**PLANNING COMMISSION MEETING
MUNICIPAL CENTER COUNCIL CHAMBERS
Tuesday, October 1, 2013**

5. Somerset Subdivision, East Side of Exeter Rd., North of Neshoba Rd. - Request Preliminary and Final Plat Approval - Lee Davidson, w/The Reaves Firm – Applicant

6. The Preserve PUD, Eastern Terminus of Woodlane Drive and Beaverwood Drive – Request Amendment to the Approved Plan to Modify a Landscape Easement

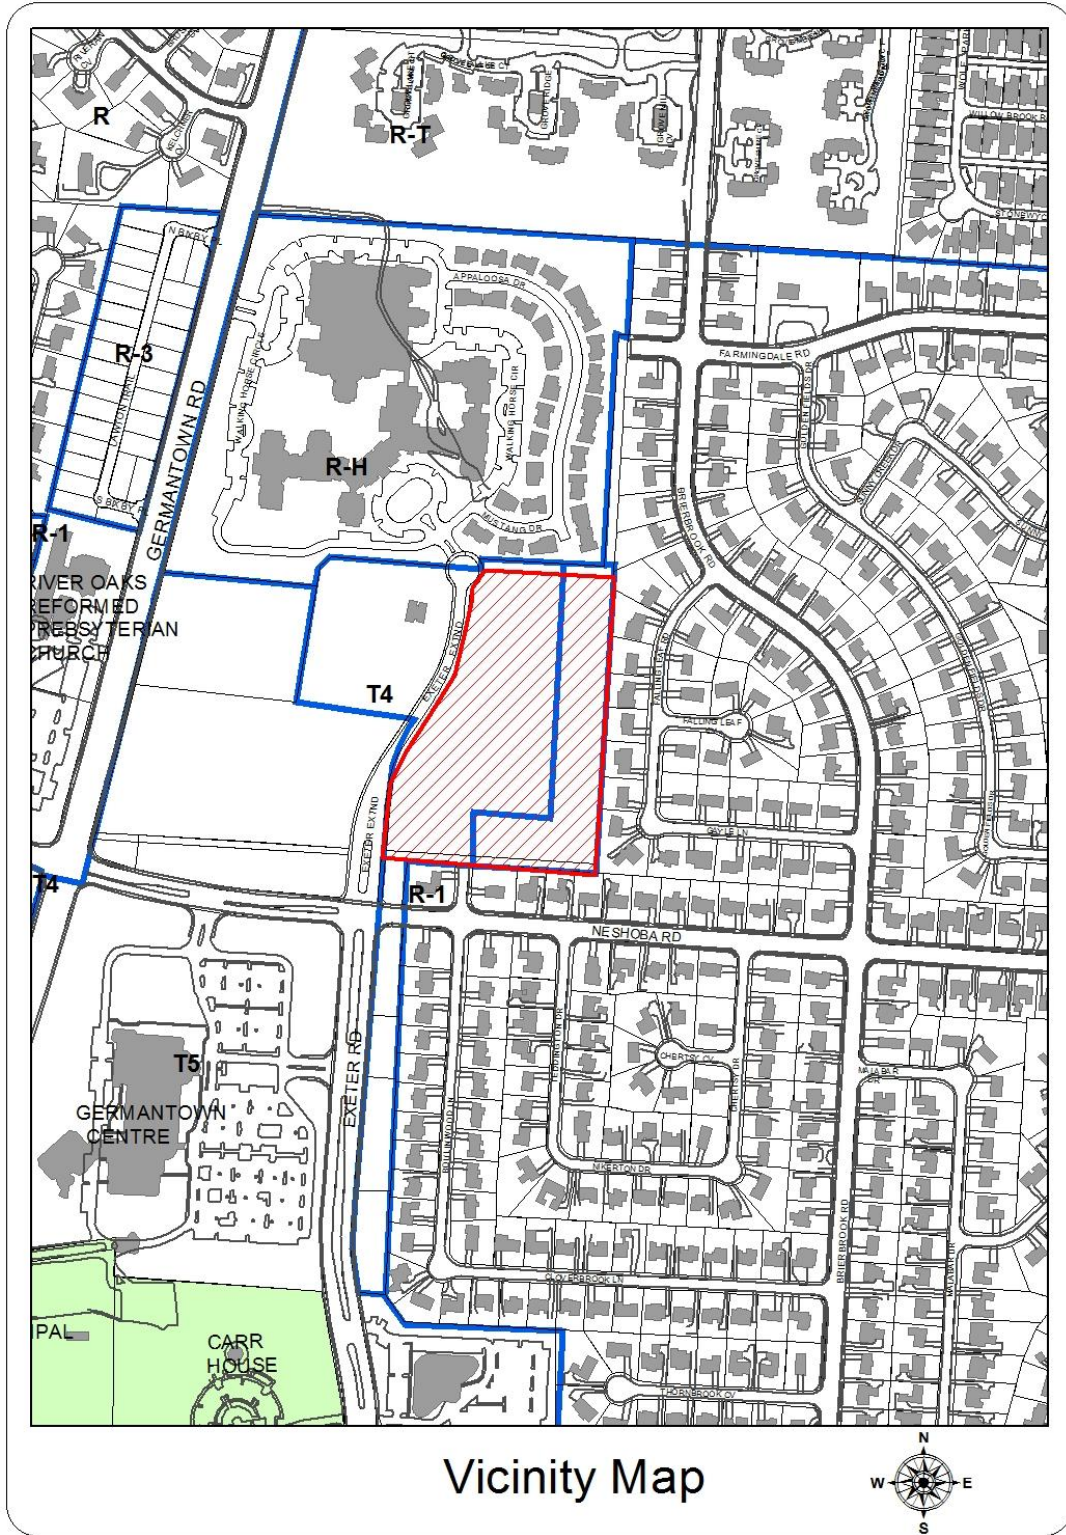
STAFF RECOMMENDATION: **Approval** provided the following comments are addressed:

1. The landscape plan shall clearly indicate that the six-foot wood fence is to be provided along the south and east sides of the subdivision and along the north side of lots 19 - 22 and the detention area.

1. Note on the plans the locations of MLGW transformer boxes and streetlights.
2. Provide a video assessment of the existing storm drain system in the vicinity.

3. Provide special compaction notes for all ditches.
4. Provide greater spacing between the water and sewer service lines and taps.
5. A non-destructive testing agreement for damage to Exeter Rd. from hauling operations shall be entered into.

6. On the Utility Plan, show the tap for the fire sprinkler systems.
7. Provide an irrigation system for the Common Open Space areas.
8. A no. 10 inlet is not adequate to accommodate 0.80 acres of water. Revise accordingly.

9. Add a note to the plans stating that *all private alleys are dedicated as public access easements. All private alleys (COS D) and common open space shall be maintained by a homeowners association.*

10. On the Grading and Drainage Plan, indicate a means to catch surface drainage from Boulinwood into Lots 4 and 5.

11. Provide a detail on the treatment of the dead-end of Boulinwood. Consult the Manual of Uniform Traffic Control Devices and provide fencing, landscaping, and barricades as appropriate.

12. Locate water and sanitary sewer service lines and clean-outs in areas other than the middle of lots (where walkways are placed) and within driveways.

13. Include the dimension of the distance from the drain easement and the building setback line to the property line, on Lot 18.
14. Sidewalks within all Common Open Space areas shall be installed by the developer as part of the subdivision development, prior to initial acceptance.

15. Label the alleys (1, 2, 3 ... A, B, C, for ex.) to allow for differentiation.
16. Provide a fence and landscape buffer easement along the south, east and north boundaries of the subdivision.

17. Provide a utility easement along Exeter Rd.
18. The public drainage easements near the south and east boundaries of the subdivision shall be private easements.

19. On the Landscape Plan, replace the Emerald Green Arborvitae with Hollies.

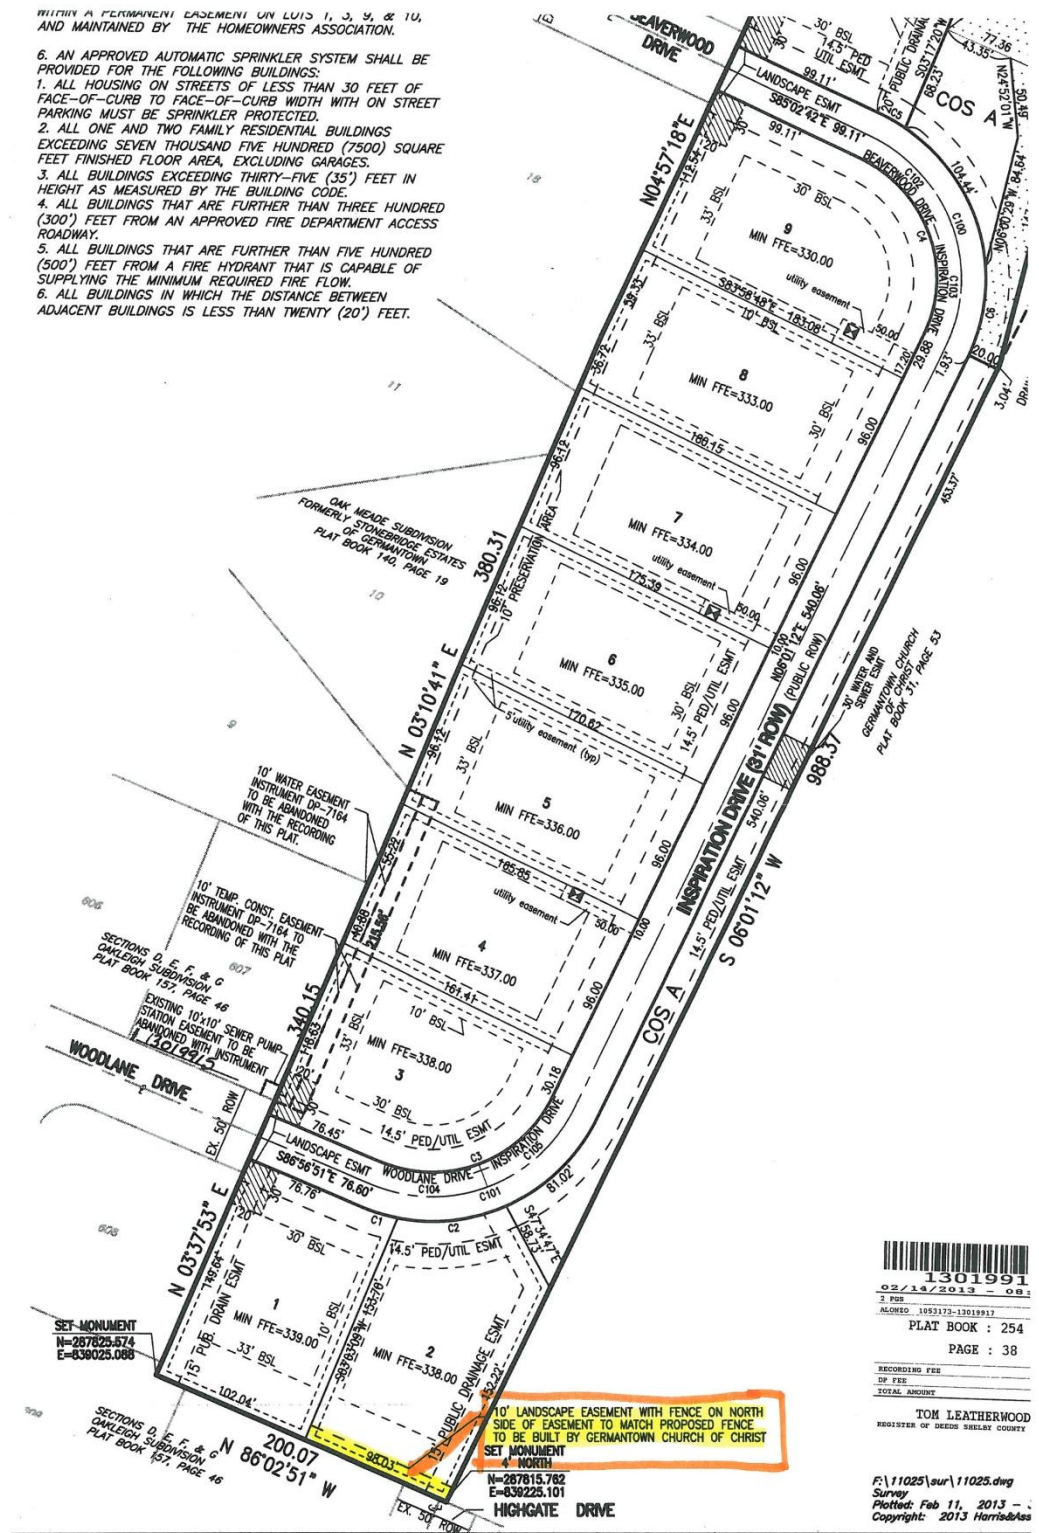
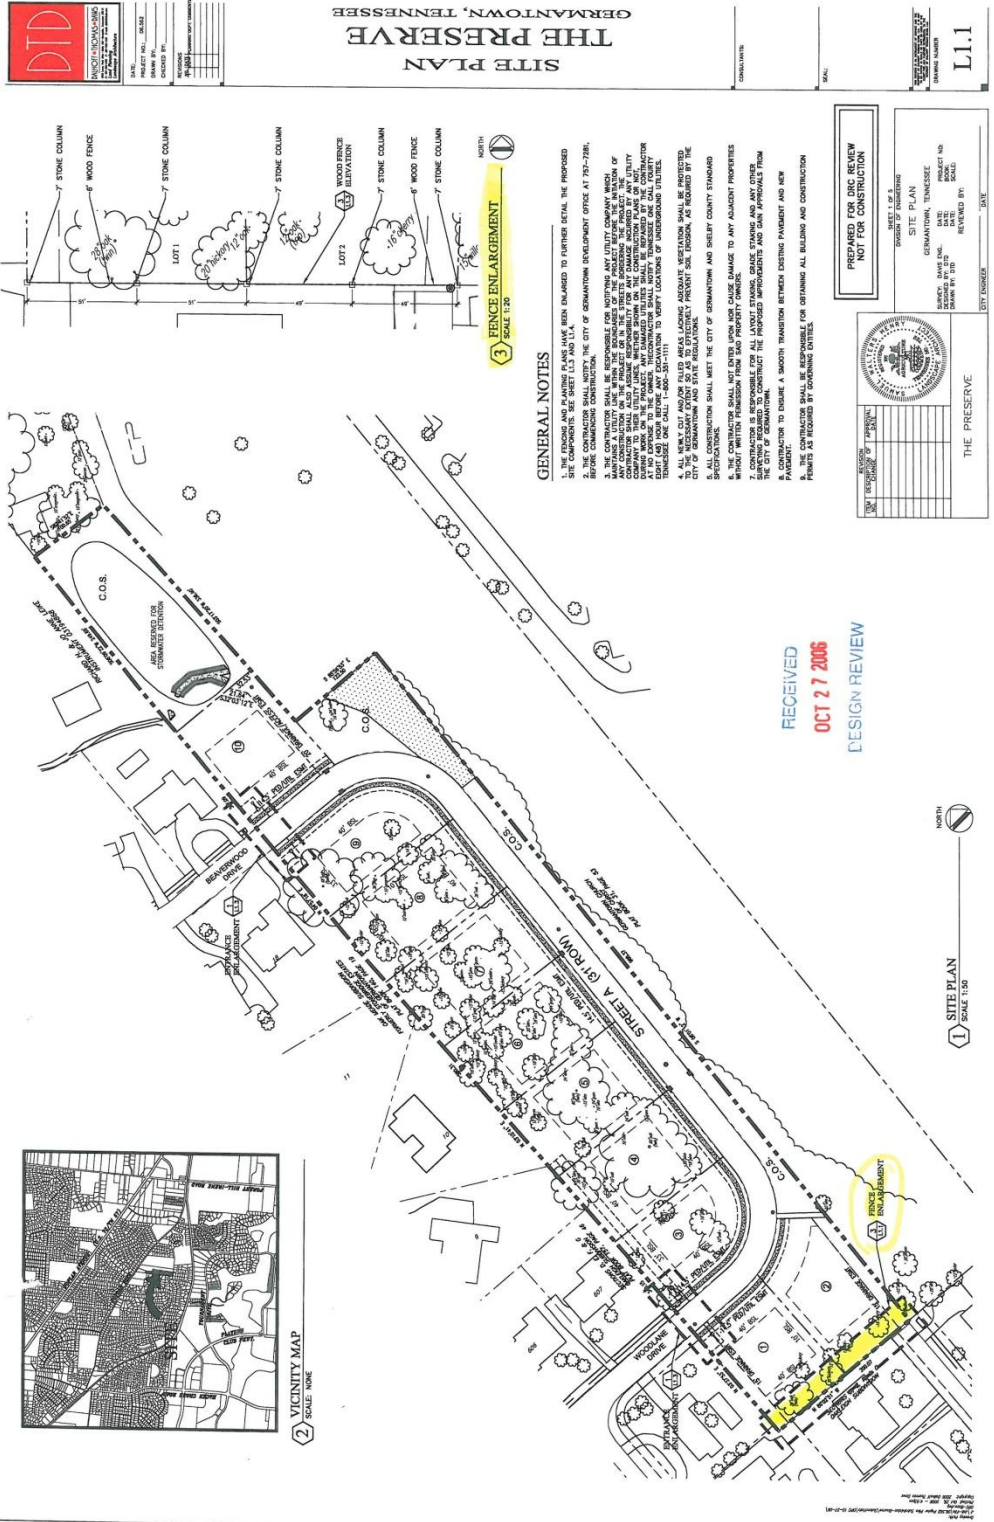
DISCUSSION: The specific request by the applicant is to remove a 10-foot landscape easement on the southern lot line of Lots 1 and 2. During the initial approval process of the subdivision, the developer agreed to place a 10 foot wide landscape easement between 3109 Highgate and The Preserve. The

easement requires a wood fence to be constructed on the **north side of the easement**, within Lots 1 and 2. The Design Review Commission approved the design of the fence on November 28, 2006. The easement was then recorded on February 14, 2013.

Dick Leike, 8643 Poplar Pike stated he wanted to remove the 10-foot landscape easement and fence between lot 2 and the adjoining property. He has reached an agreement with the adjoining lot owner.

1. Include a note on the plat, under “sidewalks”, to provide a sidewalk stub and ramp on Lot 3.
